# Review of Northwest Natural Gas 2022 Integrated Resource Plan—Final Report

Assessing Compliance with the Oregon IRP  
Guidelines and the Greenhouse Gas Reduction  
Requirements from the Climate Protection  
Program

**Prepared for Staff of Oregon Public Utilities Commission**

March 20, 2023

Figure 2. Total system annual load (deliveries) by scenario (NWN Figure 3.38)

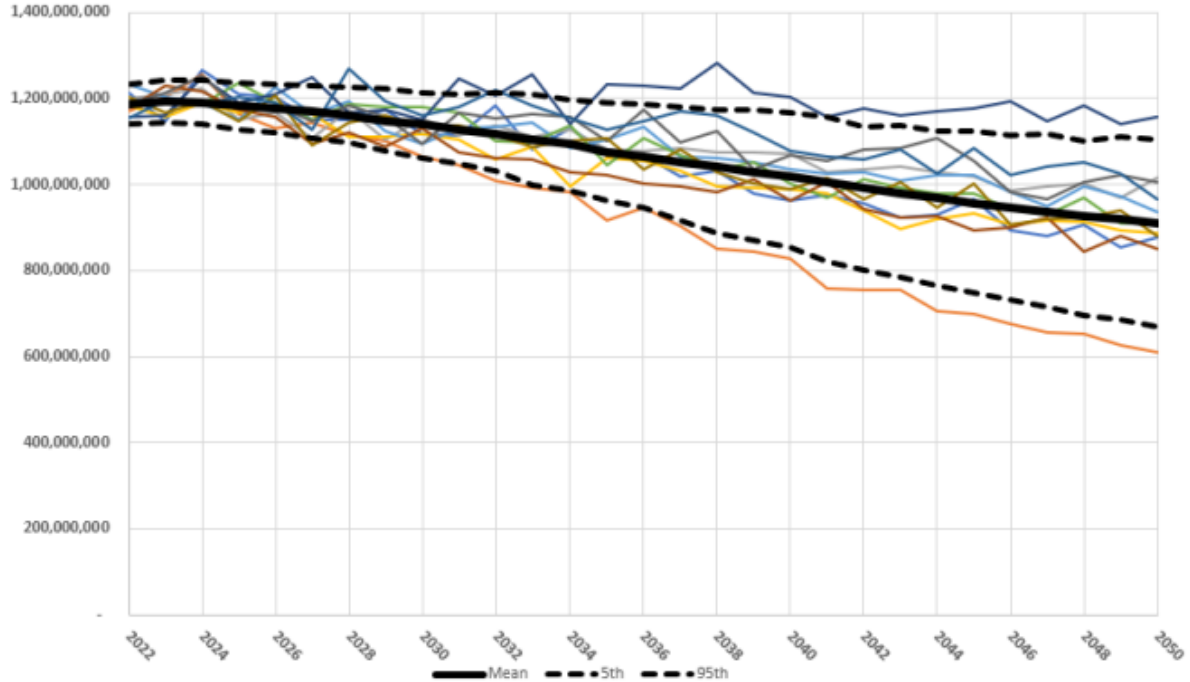
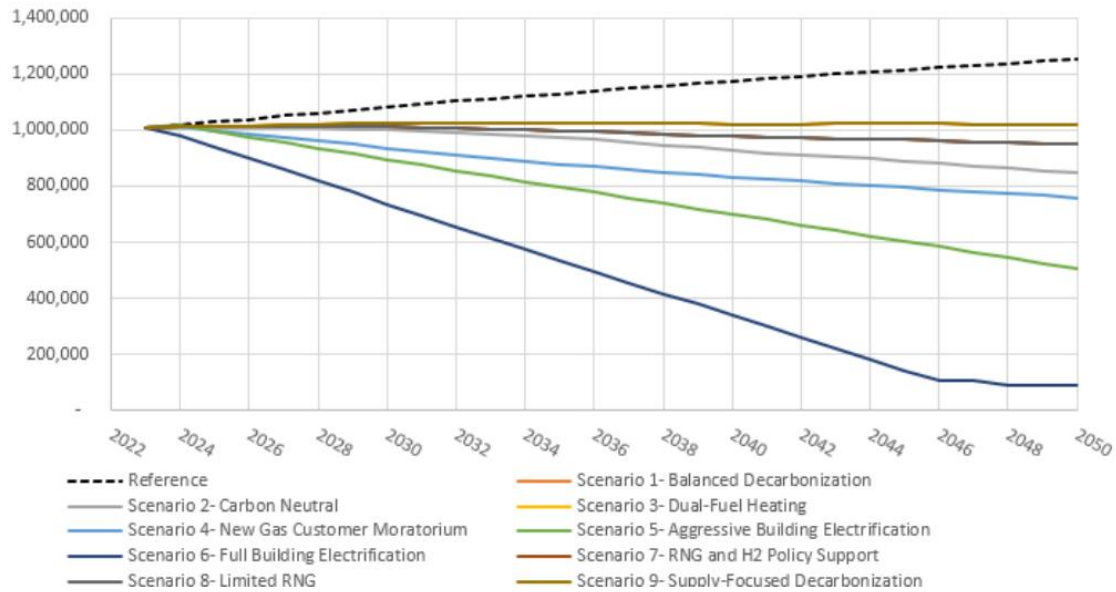
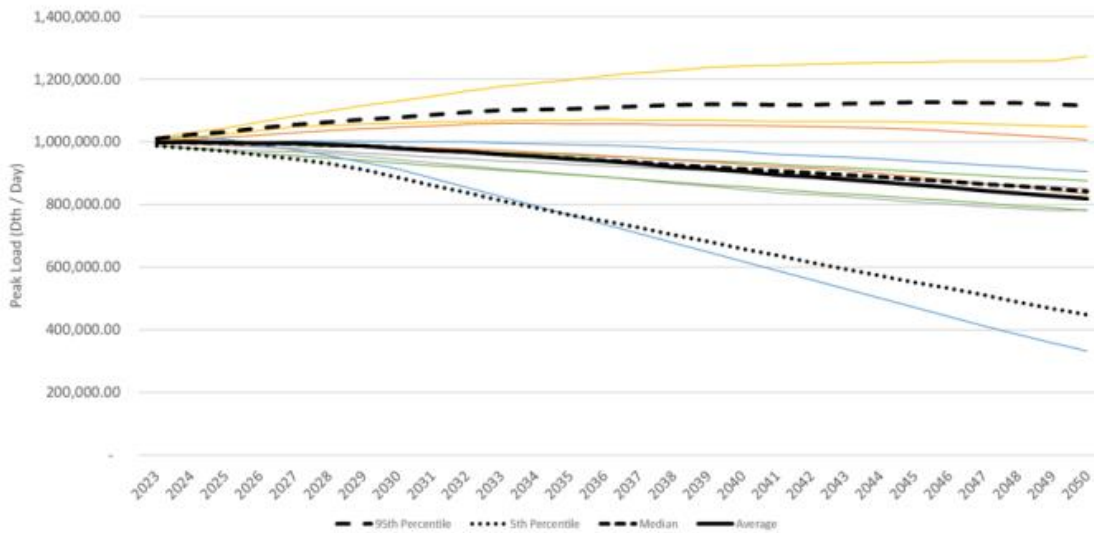
Figure 2 through Figure 5 show the range of load used in the Monte Carlo simulation analysis.

The annual energy deliveries forecasts (Figure 2 and Figure 3 above, corresponding to NWN Figures 3.38 and 3.40) illustrate that the preferred portfolio, which is the “average” line seen in the stochastic simulation (Figure 2, or NWN’s Figure 3.40), roughly aligns with the load trajectory seen in Scenario 1.

For the peak day forecast load, the preferred portfolio levels (Figure 5, or NWN’s Figure 3.42) are lower than the peak day load seen in Scenario 1 in Figure 4 (NWN’s Figure 3.41) and align roughly with Scenario 2.

**Figure 11. CCI credit and supply resource compliance price, all scenarios except Scenarios 7 and 8**

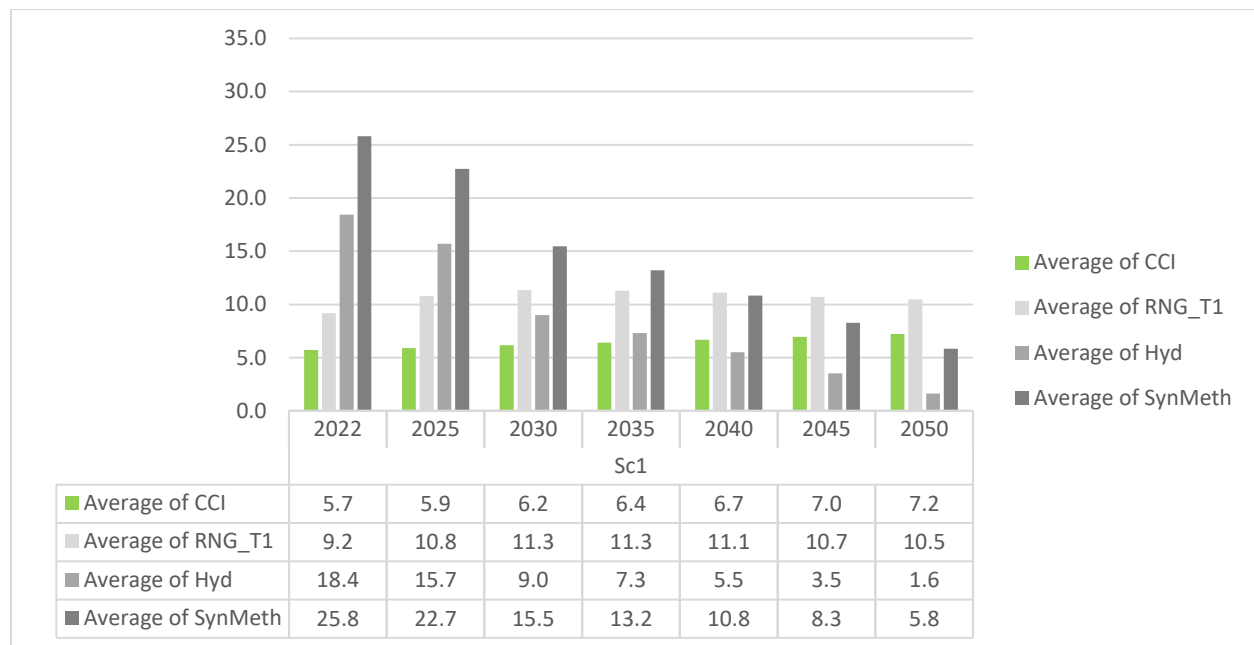
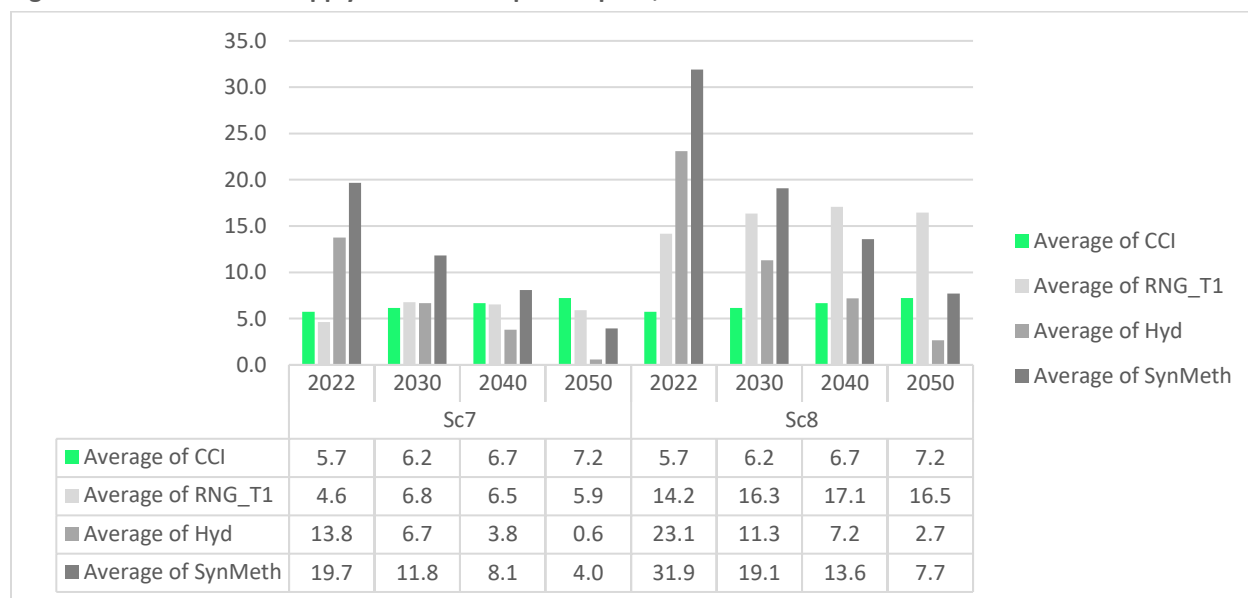
For all scenarios, the trajectory of CCI credit prices remains the same across all scenarios, increasing slightly over time. For most scenarios, NWN’s trajectory of pricing for RNG Tranche 1 compliance resources rises slightly from now to the 2030–2035 period, then declines slowly over the rest of the planning horizon. The trajectory of pricing for other supply-side compliance resources (hydrogen and synthetic methane) declines over the planning horizon.

The prices for RNG (either tranche 1 or 2, or hydrogen or synthetic methane) are higher than CCI credit prices until 2037 in most scenarios. In 2038, NWN projects hydrogen pricing to dip below CCI credit prices and remain below those prices for the rest of the planning horizon. NWN also projects synthetic

The pricing for CCI credits was developed as part of the CPP, after passage of SB 98. Notably, CCI credit prices are significantly lower than RNG prices through 2037. However, NWN selects the use of RNG to meet CPP compliance requirements within its PLEXOS modeling<sup>39</sup> rather than allowing all of the available lower cost CCI credits to be first fully selected by the optimization model.

**Figure 13. NPV RR effect by scenario of substituting CCI credits for RNG, up to Allowed level of CCI credits**

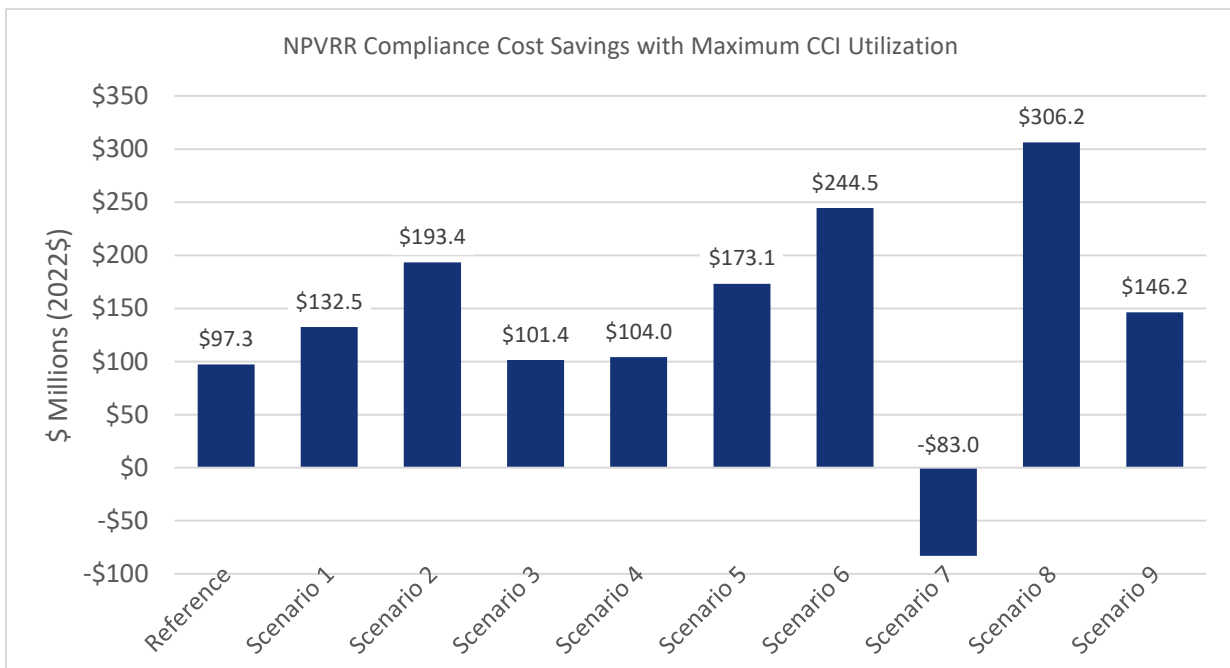
As seen in Table 4 and Table 5 above, the value of using CCI credits instead of procuring RNG to meet CPP compliance is at its highest when RNG costs are high, in Scenario 8. But in all scenarios except the low-cost RNG Scenario 7, using CCI credits at their maximum levels results in ratepayer savings.

- The economically optimal mix of RNG, CCI credits, and load reduction through electrification is not assessed under NWN's construct.
- To lower overall ratepayer costs, NWN should fully utilize CCI credits that cost less than RNG solutions in the first part of the planning horizon.

**Figure 14. Magnitude of 29-year stream of revenue requirements used in NWN PLEXOS modeling**

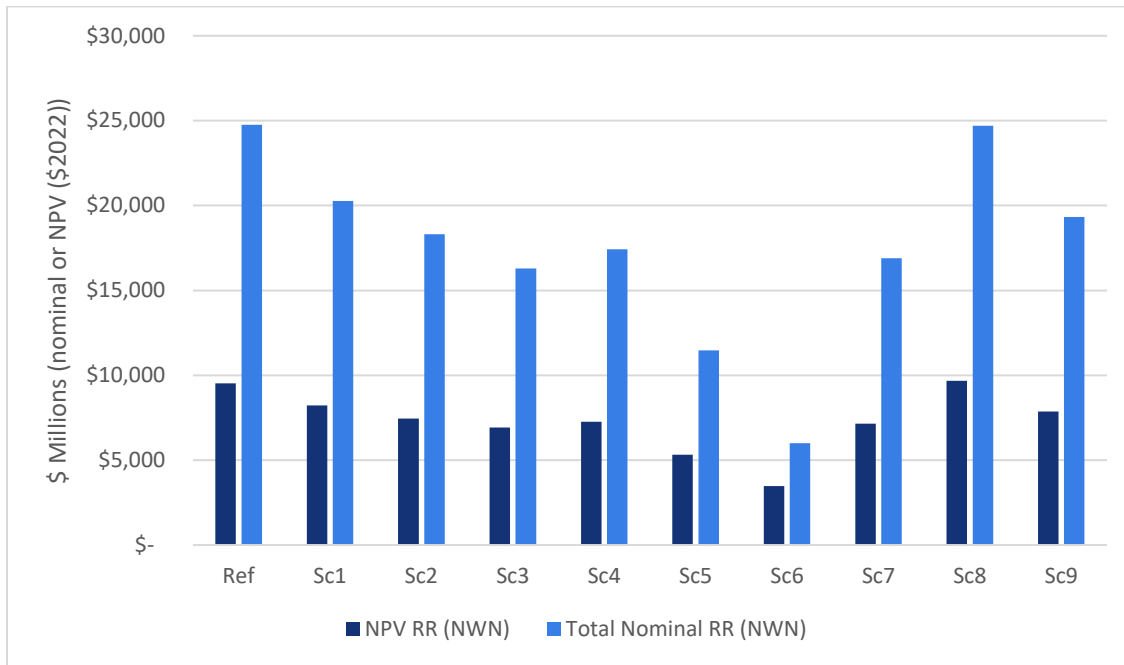
Figure 14 below is a summary of the revenue requirements for NWN scenarios 1 through 9, plus the reference scenario, using NWN’s cost components. The chart shows both nominal and NPV values. The costs shown are those “partial” revenue requirement costs that NWN includes in its modeling approach. NWN does not include in its modeling the remaining revenue requirements, including those arising from past and projected capital investments in the distribution system.

**Figure 15. Net present value of 29-year stream of revenue requirements by scenario and by component**

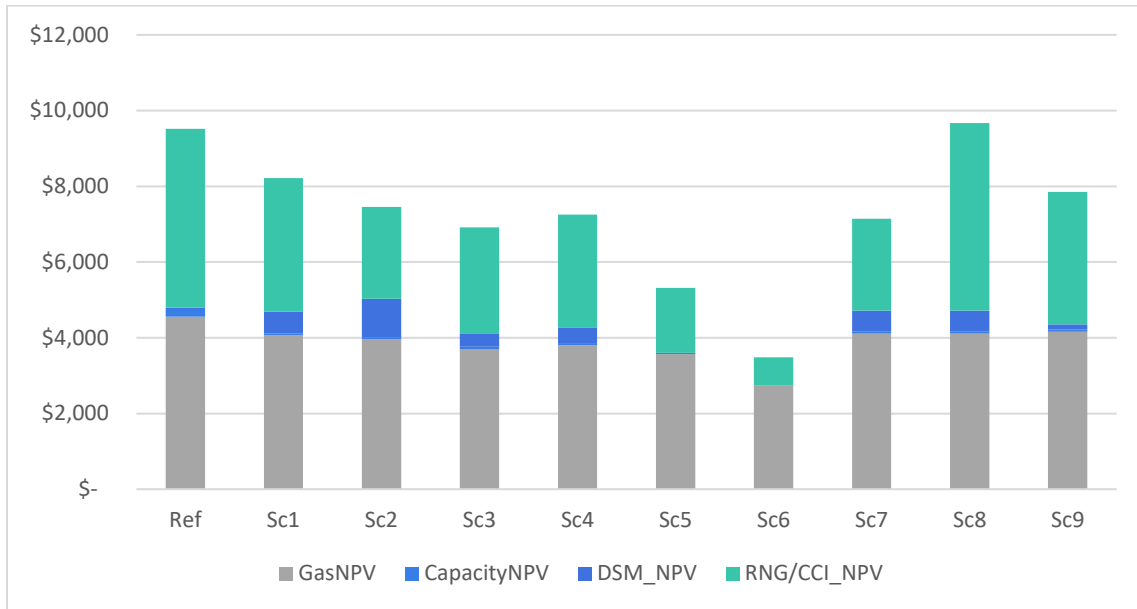
Figure 15 below shows the NPVRR cost categories by scenario. Gas supply and compliance costs dominate total costs. Incremental capacity and DSM costs represent a marginally small share of costs.

Figure 16. NWN’s Partial revenue requirements by year by scenario in PLEXOS model

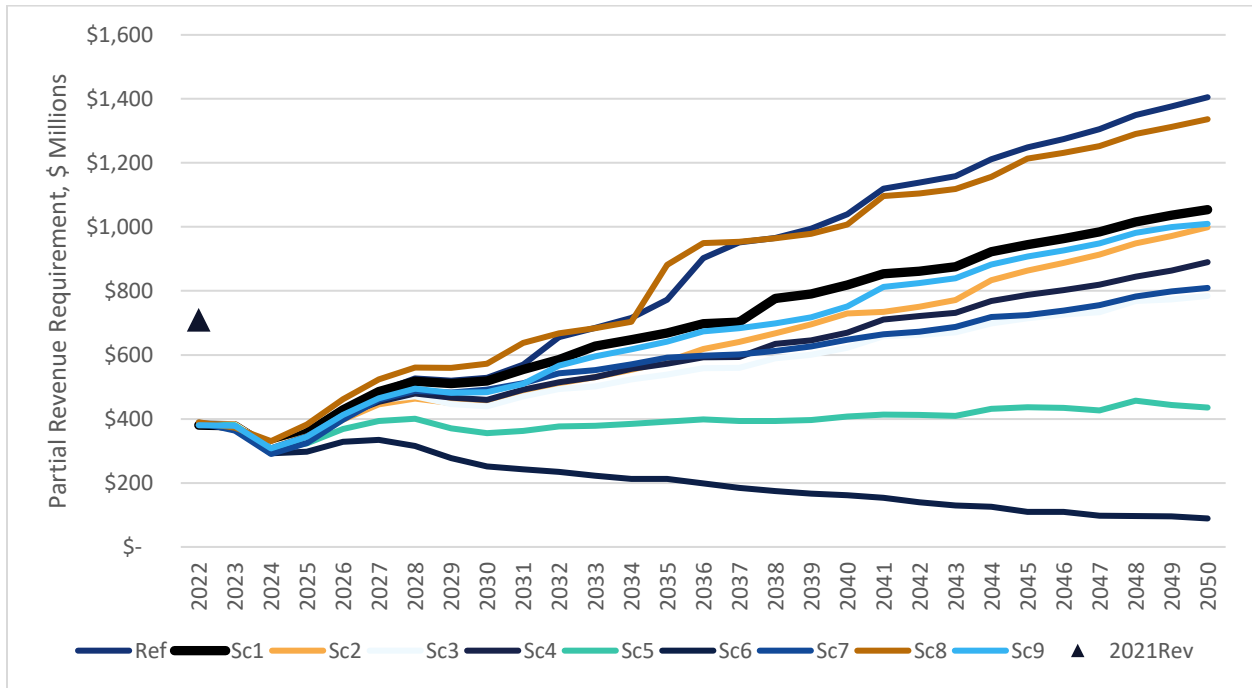
The total revenue requirements analyzed in the PLEXOS model in each year are on the order of roughly one-half of NWN’s total revenue requirements, based on the 2021 actual revenue requirement value from NWN<sup>67</sup> as shown in Figure 16.

Figure 17. Oregon CPP compliance costs by year by scenario (NWN)

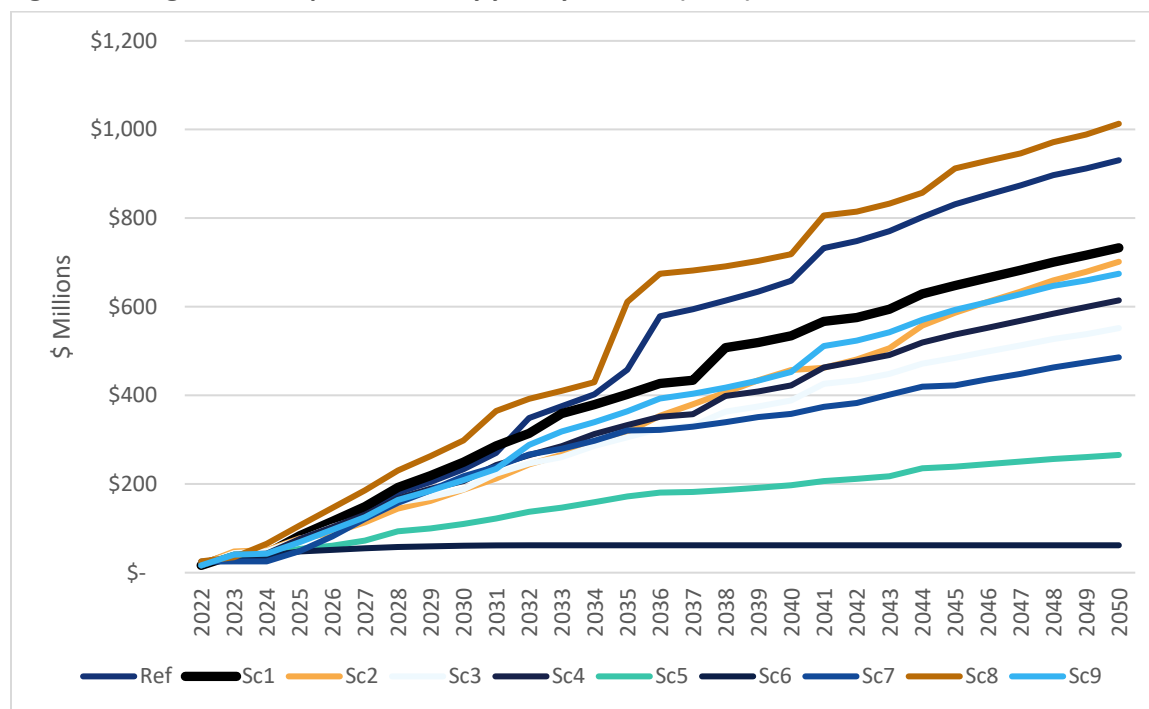
The lowest compliance costs are seen in Scenario 6, which contains the lowest level of gas load. The highest level of compliance cost is seen in Scenario 8, which is the only scenario that reflects a higher cost for RNG (biofuel, hydrogen, and synthetic methane fuels). The compliance cost streams are composed of RNG, CCI, and incremental demand-side management costs that in combination meet the CPP requirements for total emissions from the sales and transport sectors.

Figure 18. Comparison of NPVRR across all scenarios, inclusive of electrification cost estimate, 2022-2050

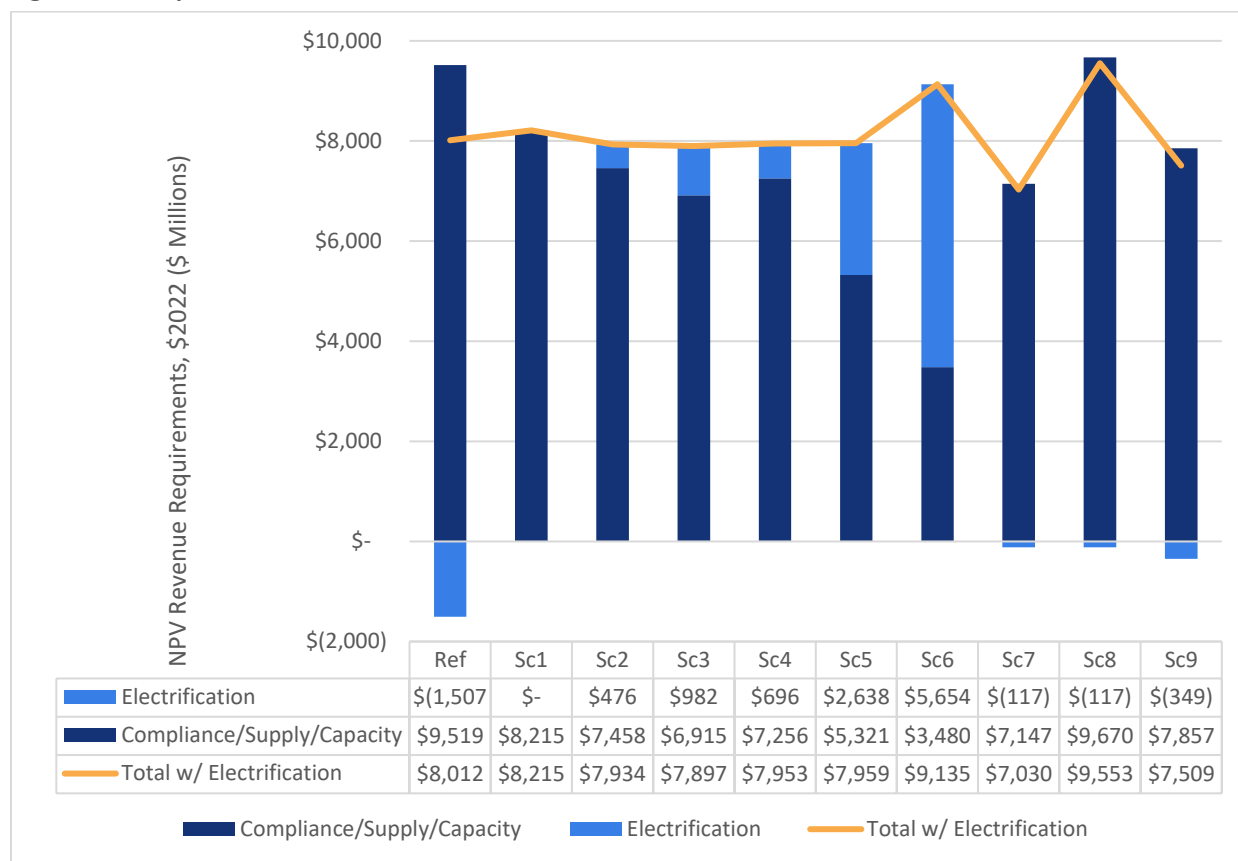
Figure 18 above illustrates the following:

required to reduce the gas loading. It also begins to illustrate the importance of sensitivity testing of scenarios to help understand the relative economic impact of a planning path that potentially relies on RNG. Under scenarios of higher RNG costs, even the most aggressive of the electrification scenarios (Scenario 6) costs less.

**Figure 19. NPVRR comparison with electrification costs, CCI-for-RNG substitution, and distribution capex savings, 2022-2050**

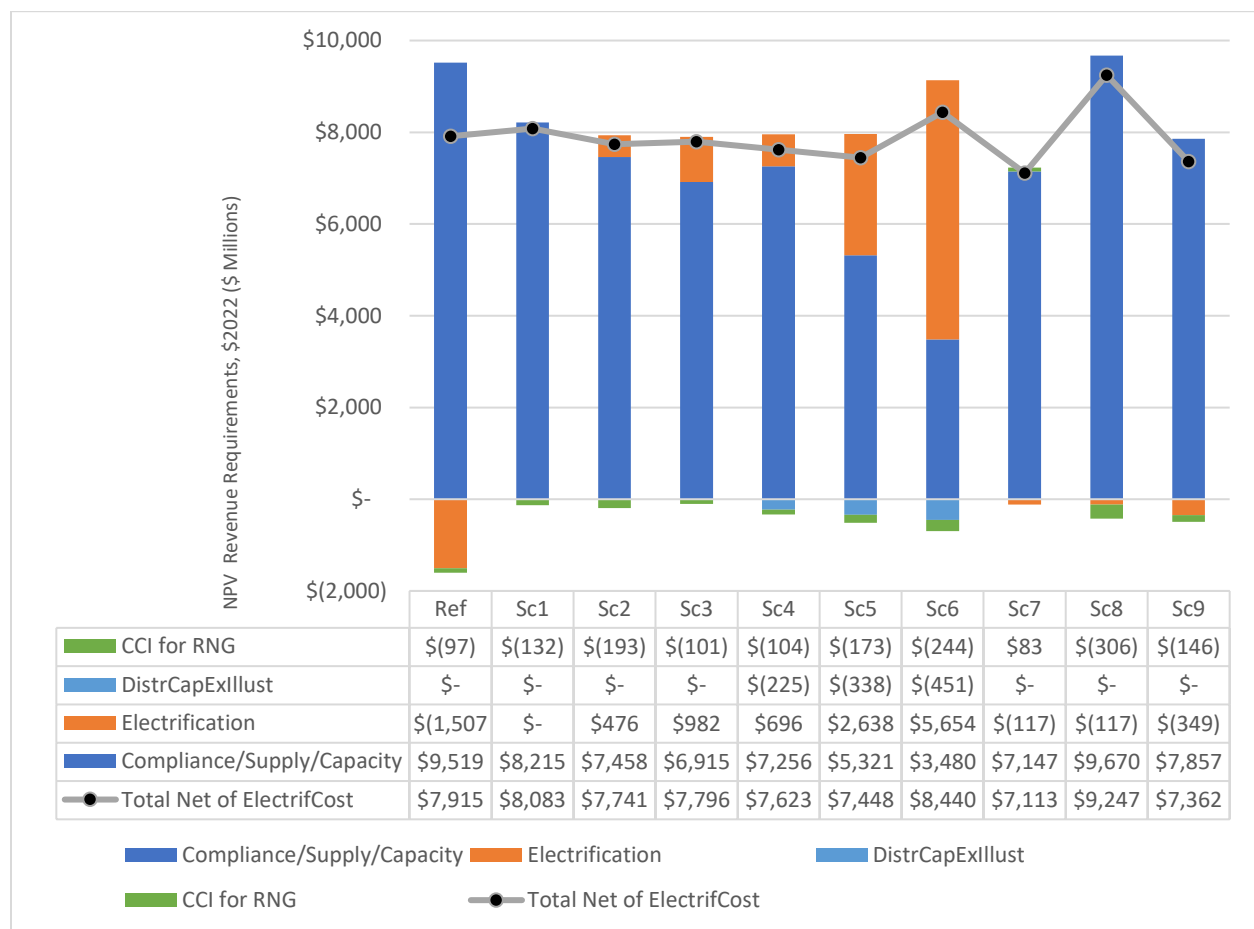
Figure 19 above illustrates that consideration of revenue requirement cost savings from alternative resource pathways can be used to compare outcomes against NWN’s preferred scenarios, in this case using Scenario 1 to reflect NWN’s preference.

The two figures shown above, Figure 18 and Figure 19, demonstrate how directly considering the costs of load not served by gas, but served by electricity, allows for a rough comparison across scenarios to gauge the relative value of planning solutions using RNG versus solutions with electrified load. These two paths result in the same, or at least analytically similar, levels of decarbonization. Uncertainty associated with the level of decarbonization resides in each pathway. For electrification pathways, there is uncertainty with the marginal greenhouse gas emissions associated with increased electrification-derived load. For RNG pathways, there is uncertainty associated with the true level of net emissions associated with the combustion of RNG. NWN does not directly address this risk in its analysis.
